Economic and Social Council

Guidelines for Waterway Signs and Marking (Resolution No. 59, revised)

Draft amendments to the Guidelines for Waterway Signs and Marking (Resolution No. 59, revised)

Note by the secretariat

Figure 1a

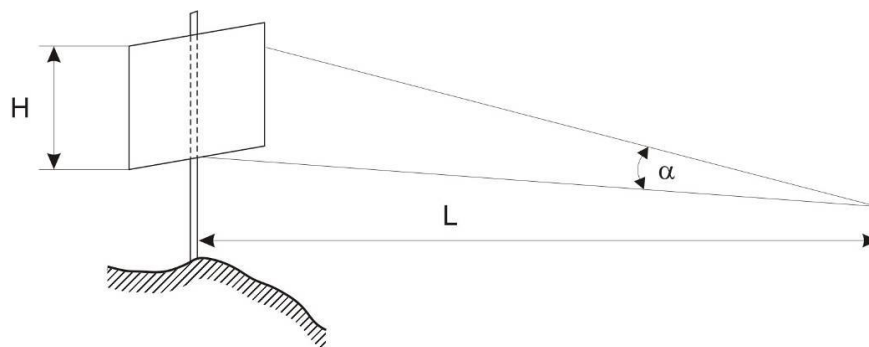
3.8 The ~~largest~~ **minimal** angle of distinction ~~by day in daytime~~ for simple shapes (quadrant, triangle, circle, cylinder, cone, sphere etc.) ~~shall be within is~~ **between 3.5°—5° scale 3 and 5 angular minutes**, and for complex shapes (numbers, letters, etc.) ~~within 5°—8° scale between 5 and 8 angular minutes~~. For the boatmaster to be able to recognize **the daymark** (without any optical aids) ~~the shape of the sign~~ at appropriate distances and visibility, ~~the above mentioned implies that~~ the following formula can be used for **the calculation of the required minimum signs² dimensions of simple and complex shapes:**

$$H = L \cdot \operatorname{tg} \alpha \cong L \cdot \sin \alpha$$

Table 1 shows that a shape of a sign with dimension $H = 0.5$ m is recognizable at distance $L = 500$ m and viewing angle $\alpha = 4^\circ$; when $L = 1,000$ m, then $H = 1$ m, etc.

Figure 1

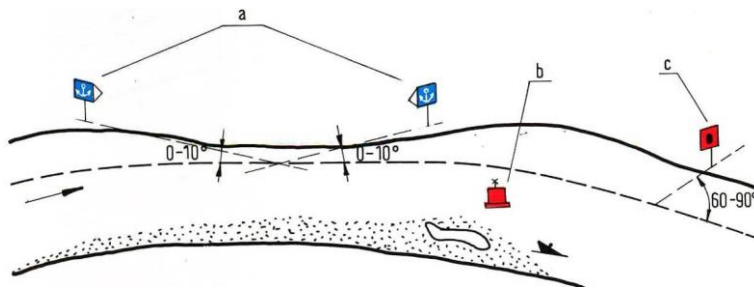
Bank marks which are used in relation to navigation in both directions (upstream and downstream)⁹ shall be oriented as under (a). In some cases, (better visibility) the angle between the mark and the axis of the fairway can be 10° or less. (Fig. 1, sign a).

Bank marks which are used in relation to navigation in one direction (upstream or downstream)⁹ shall be oriented as under (b). In some cases, (better visibility) the angle between the mark and the axis of the fairway cannot be less than 60° (Fig. 1, sign c).

4.1.7 Obstacles on the sides² of the fairway are always marked with floating signs ~~or signals~~⁷. When the obstacle is indicated by a single sign, it shall be placed on the upstream extremity of the obstacle, on the fairway side (Fig. 1, sign b).

Figure 2

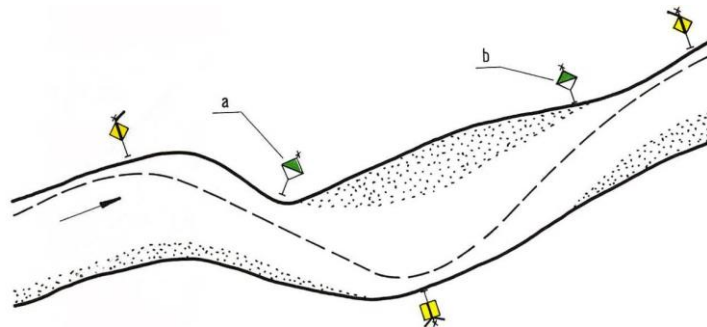
4.2.1.5²³ If the distance between two neighbouring cross-channel fairway signs is larger than the calculated visibility, and when the ~~navigation line~~ **fairway** passes ~~close to nearby~~ the bank, the bank lighted ~~sign~~, which additionally marks the position of the ~~navigation line~~ **fairway**, is placed between those two neighbouring cross-channel fairway signs (Fig. 2, sign a). The bank lighted ~~sign~~³ is also placed when the fairway² passes near the bank (Fig. 2, sign b).

Figure 3

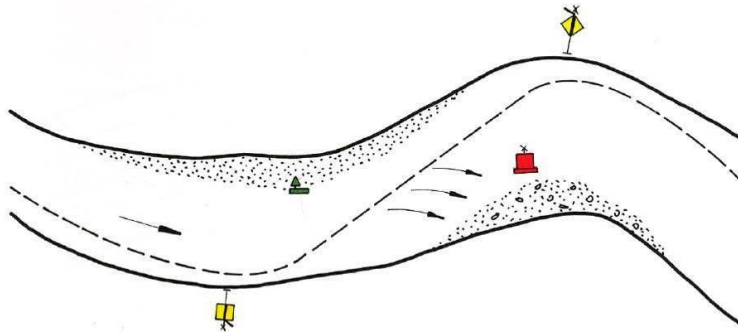
4.2.1.6 In case the direction of the current makes an angle with the fairway, when strong side winds or a similar situation occurs, the fairway² can be marked by additional navigation marks according to the local conditions (Fig. 3).

Figure 4

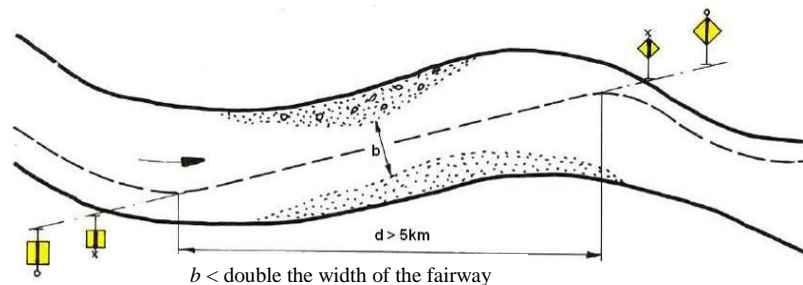
4.2.1.7²⁴ If the fairway² at longer transitions goes through the middle of the river bed or sharply crosses from one bank to another, its axis may be indicated by a **pair of two** cross-channel fairway signs, as shown in Figure 4.

The advantage is given to two cross-channel fairway signs on each side of the fairway in case of straight-line sections longer than 5 km, where the available width for navigation is less than double the width of the minimum prescribed width of the fairway for a particular sector. In this case and when the bank configuration allows so, the cross-channel fairway signs are placed on both margins of the transition (Fig. 4).

~~The advantage is also given to placing~~ **It is always preferable to** two cross-channel fairway signs on each side of the fairway when the fairway² is narrowed by certain obstacles constituting threats to navigation or other hazards marked by **floating⁷ signs⁸ and signals on the water.**

Figure 1b

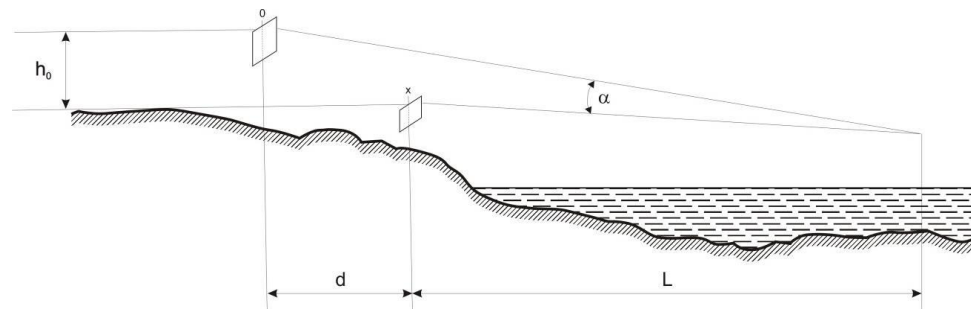
4.2.1.9 Interrelationships of the front and back signs at hidden routes shorter than 4 km are presented in Table 3.

Where (see Figure 1b):

Figure 6

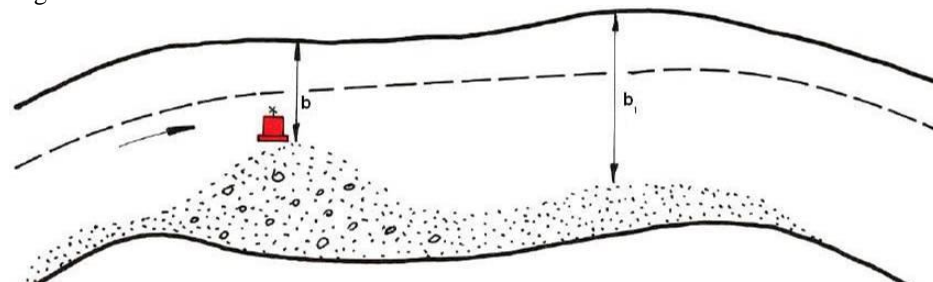
4.2.2.1 In **meandering** sectors of ~~alluvial channels~~, where the fairway passes along the middle of the river bed, or along the bank or passes slowly from one bank to the other, **floating**⁷ signs ~~and signals on water~~ are used to mark formations in the river bed or obstacles, both natural and artificial, on the sides of the fairway (banks, shores, islands, stones, sunken vessels, wrecks of bridges, etc.), when these obstacles protrude into the fairway and reduce its width (Fig. 6).

These underwater obstacles are marked in **meandering** sectors of ~~alluvial channels~~ by **floating**⁷ signs ~~and signals on the water~~ if, within the limits of width indicated above, the depth of water over such obstacles does not exceed the minimum depth reported for the sector. If the obstacle is not very wide a light **floating**⁷ signal ~~on the water~~ shall be installed ~~on the water~~ on its upstream section. A marker post or a spar may be installed on its downstream section, depending on its length.

Figure 7

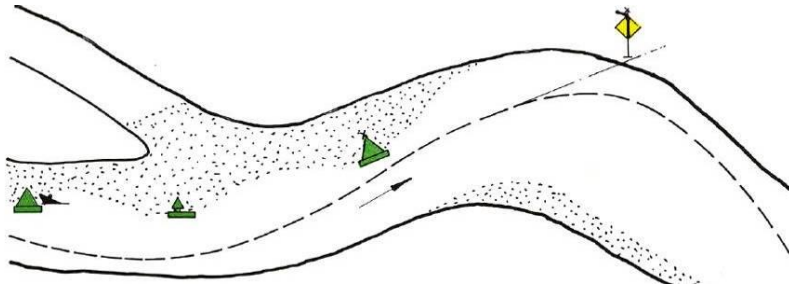
4.2.2.2 **Floating**⁷ signs ~~and signals on the water~~ marking underwater obstacles of considerable length are installed in such a way that the parts situated closest to the fairway² are marked by light² signals between which unlighted signs are placed, thus enabling a given obstacle to be marked completely (Fig. 7).

Figure 8

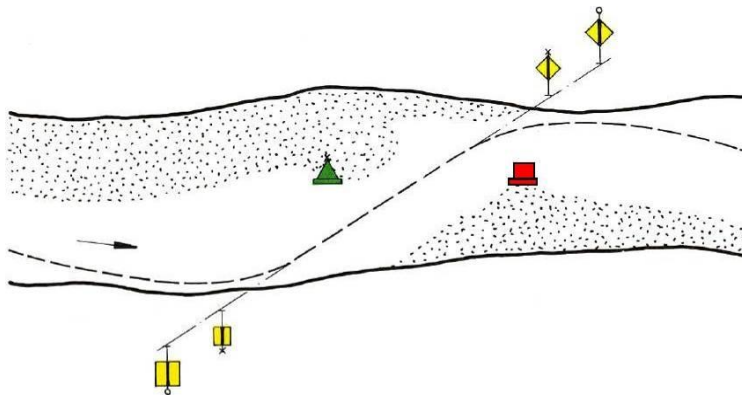
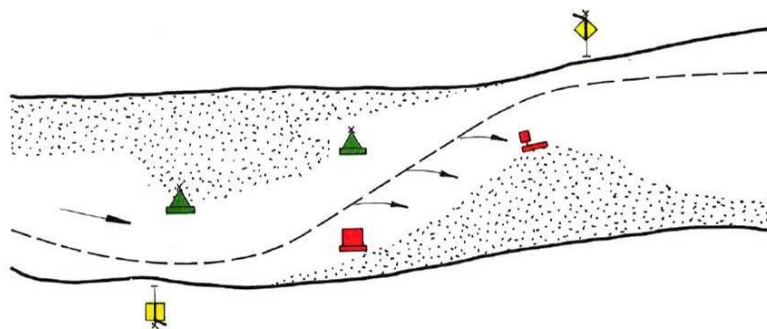
4.3.3 A fairway² passing over ~~shallow water shoals~~ is usually marked by floating signs ~~and signals~~ (Fig. 8 and 9).

Figure 10

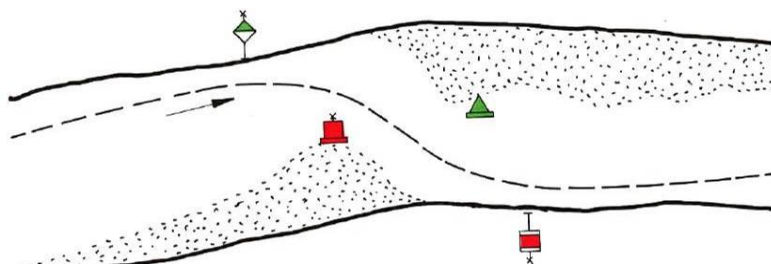
4.3.4 If the fairway passes in a straight line between sandbars, reaching far into the river bed, it is necessary to place at least two **floating**⁷ signs ~~on the water~~ at the entry and the exit of such a section: one at the top of the upstream and one on the top of the downstream sandbar (Fig. 10).

Figure 11

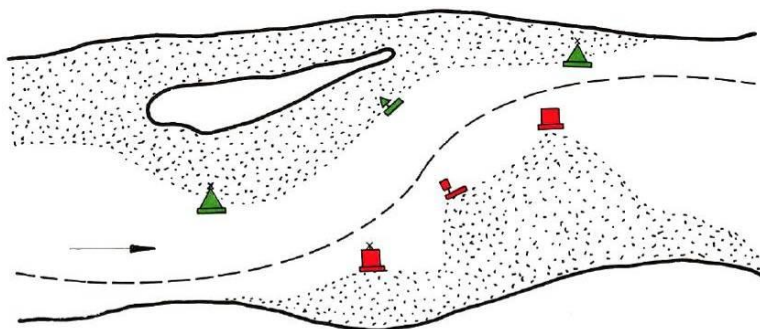
4.3.5 If the fairway² is curved in the section between sandbars, it is necessary to place additional **floating**⁷ signs ~~on the water~~ (Fig. 11).

Figure 12

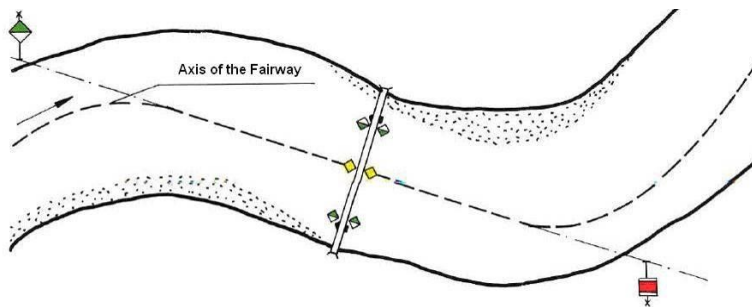
(a) If a bridge is in a meandering⁸ section of the river, the direction of vessels passing through the bridge passages may be marked by bank marks (Figure 12).

Figure 13

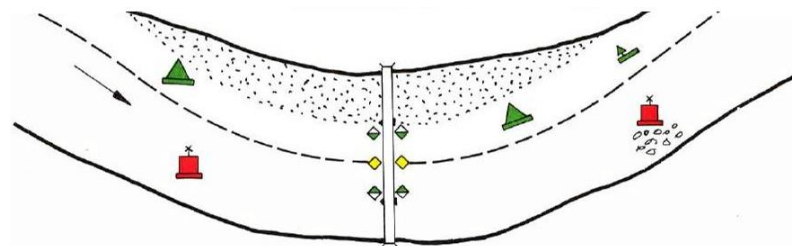
(b) If, due to a larger curvature of the fairway or for some other reasons, marking by the aforementioned signs is not possible, floating signs ~~and signals~~ (buoys, etc.), placed in order to follow the river flow, may be used (Fig. 13).

Figure 14

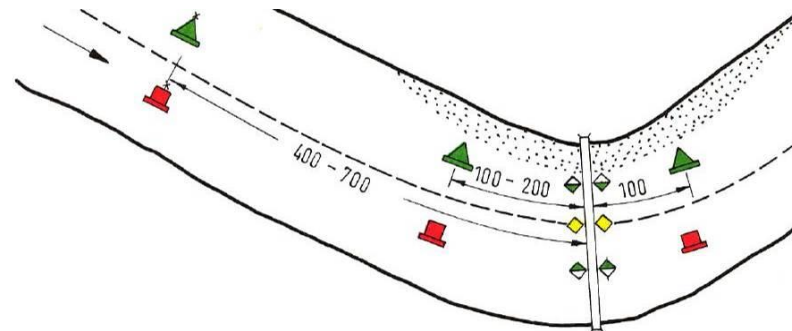
(c) If the bridge is positioned on the section where the current makes an angle with the ~~fairway-axis of the navigable passage~~³, marking may be done by two pairs of buoys upstream of the bridge. One pair of buoys is placed at a distance of 100 m – 200 m upstream of the bridge, and a second pair, 400 m – 700 m upstream of the bridge. Buoys further away from the bridge are placed in such a way that, in combination with the pair of buoys closer to the bridge, they mark² the river flow. Another pair of buoys may be placed downstream of the bridge at a distance of 100 m from the bridge (Fig. 14).

Figure 1

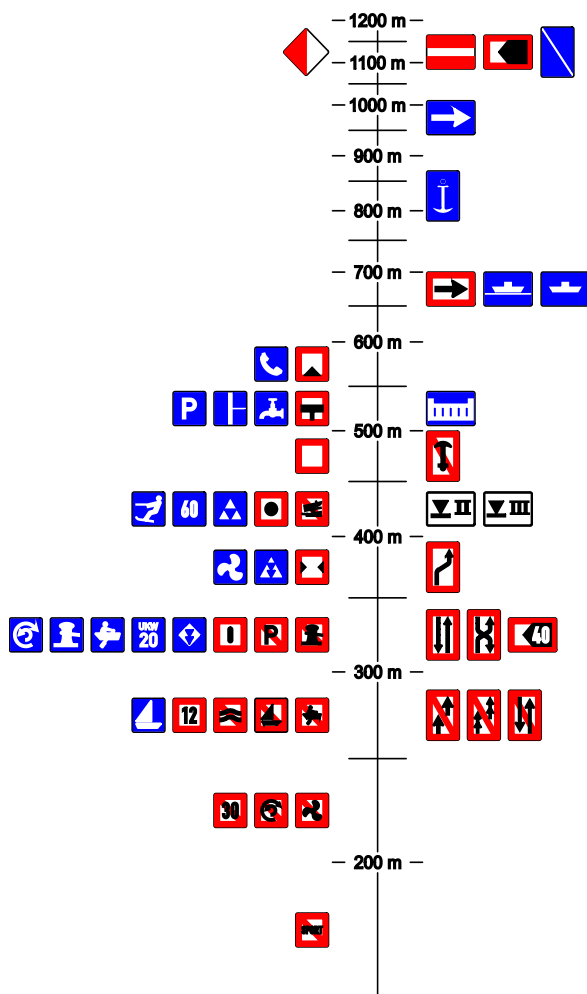
12. *Add* at the beginning:

Guidance on the maximum distances at which the various signs are visible is given in the figure below.^{34, 35} The distances are valid for boards with dimensions of 100 cm x 100 cm and 150 cm x 100 cm, with the observer positioned at a right angle to the surface of the board. When using boards of other dimensions, the distance at which the sign is visible should be recalculated according to the chosen scale.

Figure 2

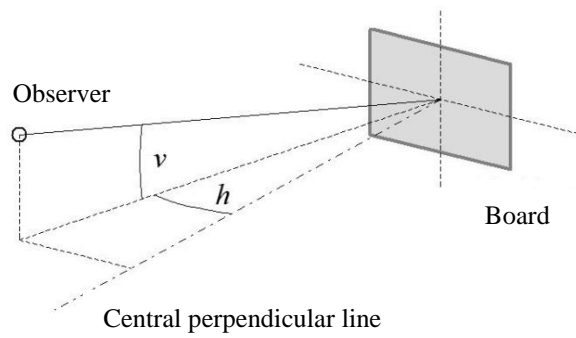
If seen askew, the maximum visibility or readability distance of the board is reduced each time by the cosine of angles h and v between the observer and the central perpendicular line: $D(h, v) = D_o \cos(h) \cos(v)$.

Figure 3

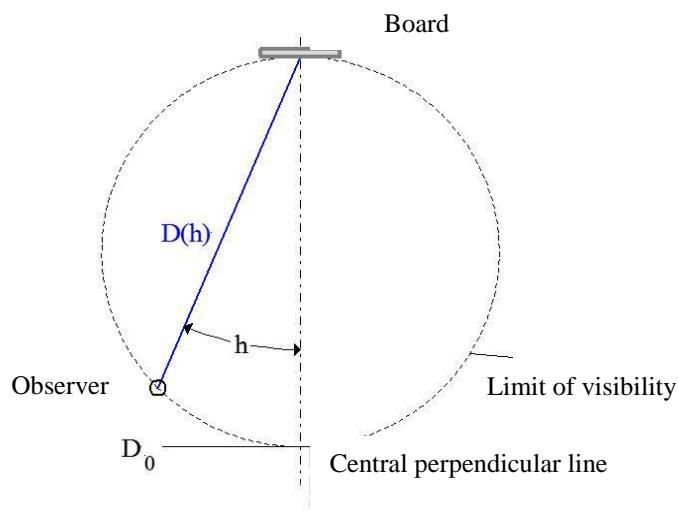
When the observer is at a great distance, the vertical angle shall be considered to be approximately 0: $v \approx 0$. In such cases, the following formula can be used as guidance to determine the visibility distance: $D(h, v) \approx D(h) = D_0 \cos(h)$. The area of visibility is thus a circle with a diameter of D_0 .

(a) A.1.1

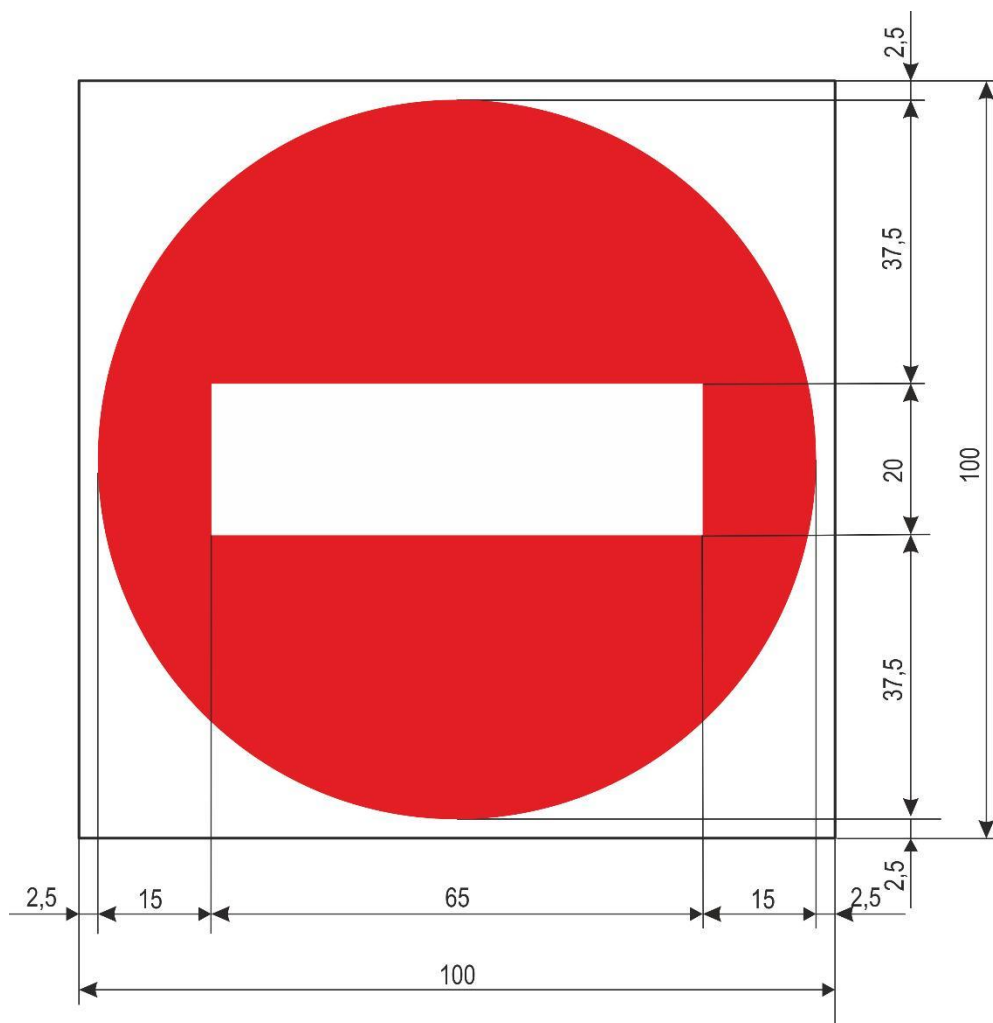
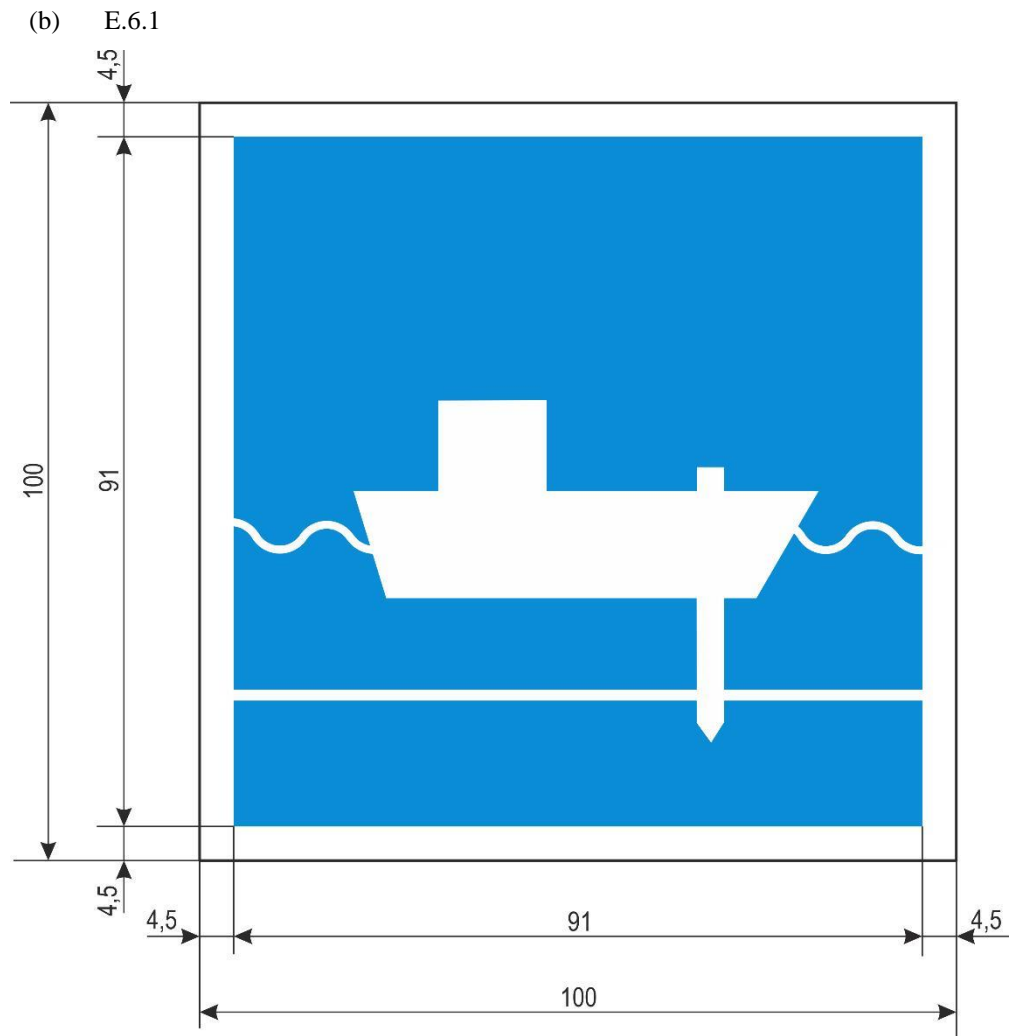
13. Add the following new sketches:

(a) A.16

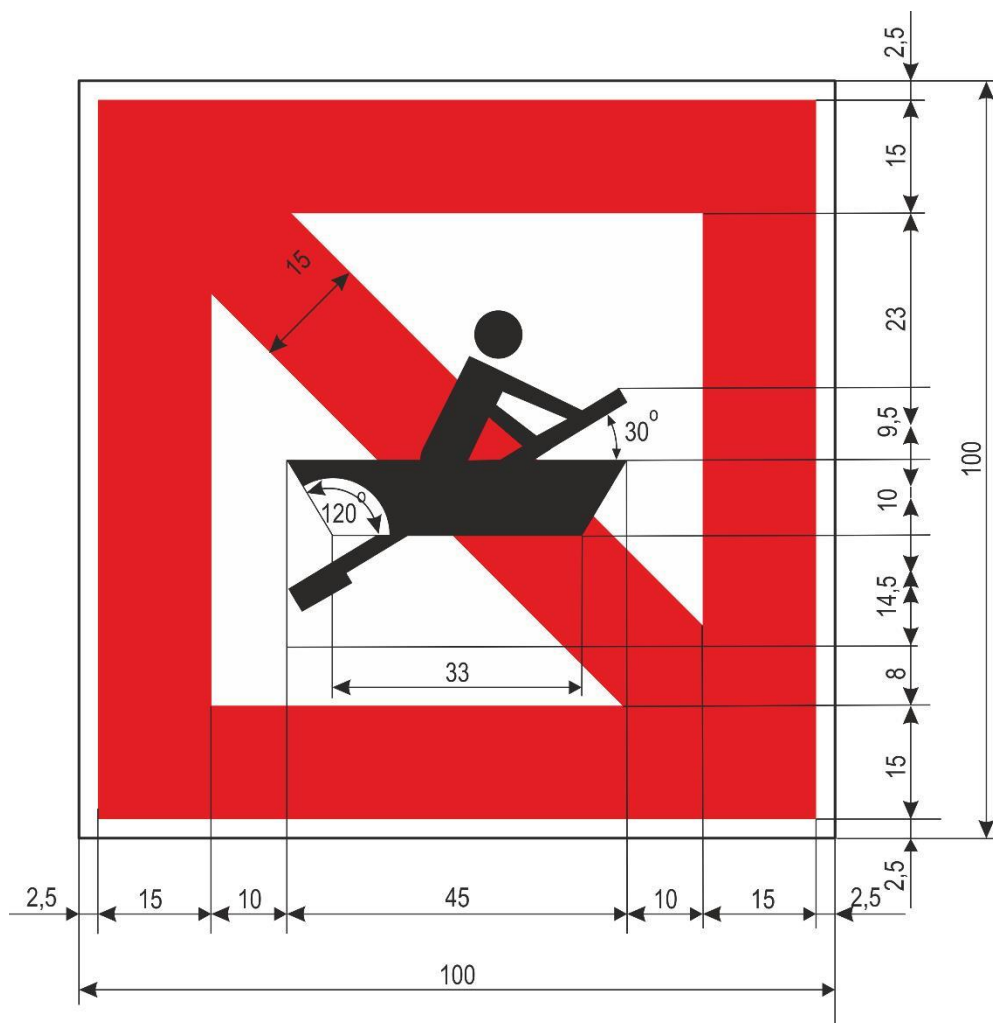
14. Replace the existing sketches with the following:
